PRODUCT / PROCESS CHANGE NOTIFICATION

PCN-000826

Semtech Corporation, 200 Flynn Road, Camarillo CA 93012

Semtech has qualified its tier 2 supplier to change the substrate's Ni/Au plating process from TSG (Traditional Selective Gold) to DPS (Double Pattern Sputter).

- **Process Flow Comparison**

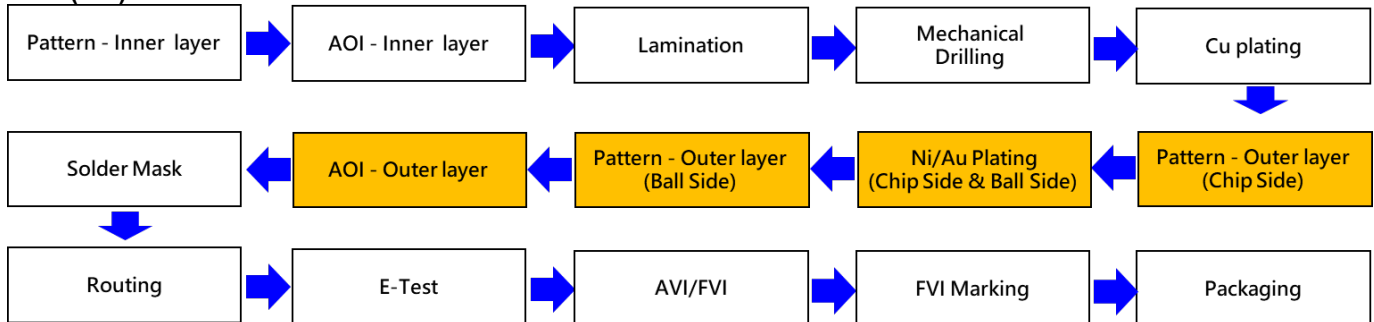
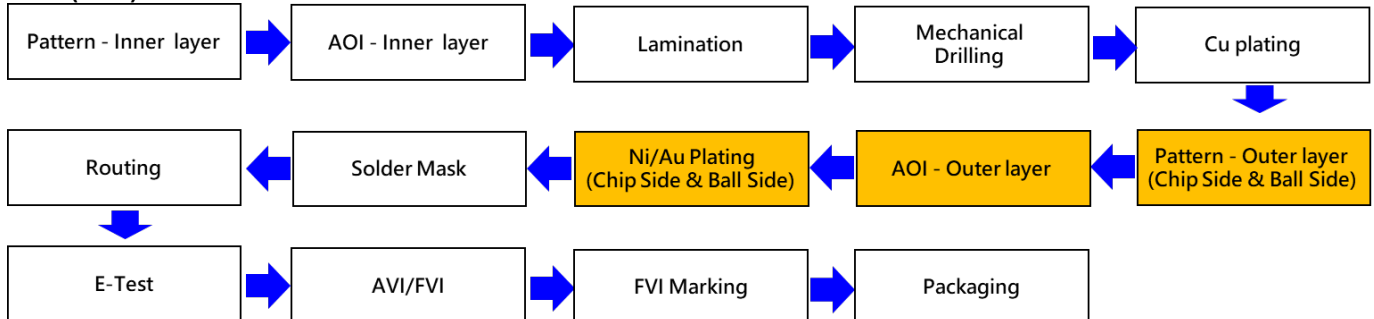
TSG (old)

DPS (new)

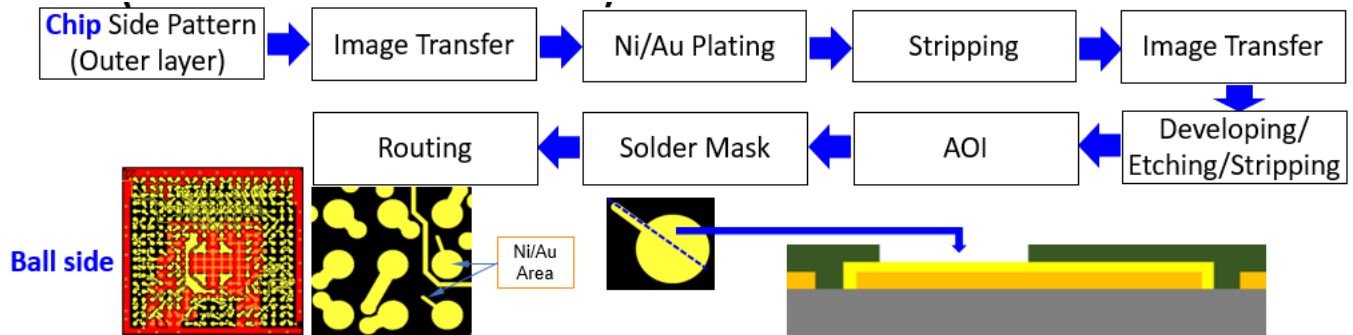
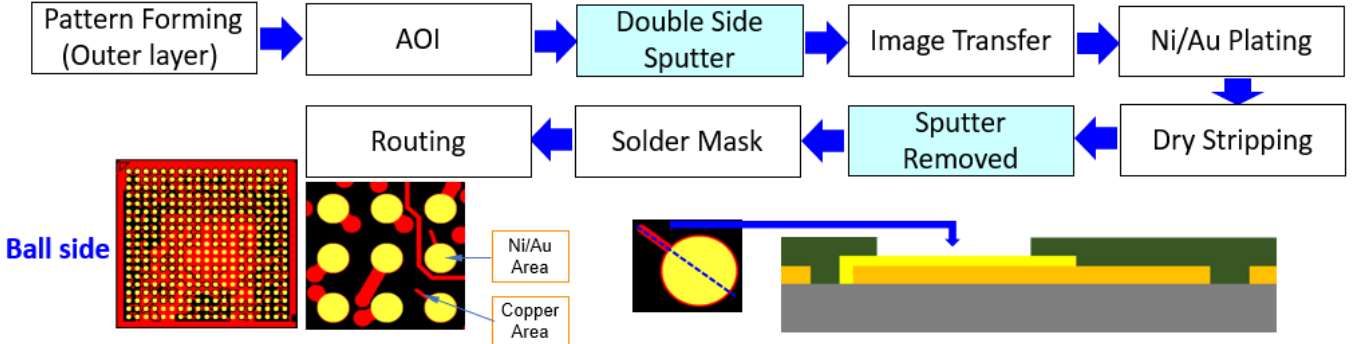
TSG (old)

The trace & ball pad of ball side with Ni/Au plating.

DPS (new)

Only ball pad of ball side with Ni/Au plating.
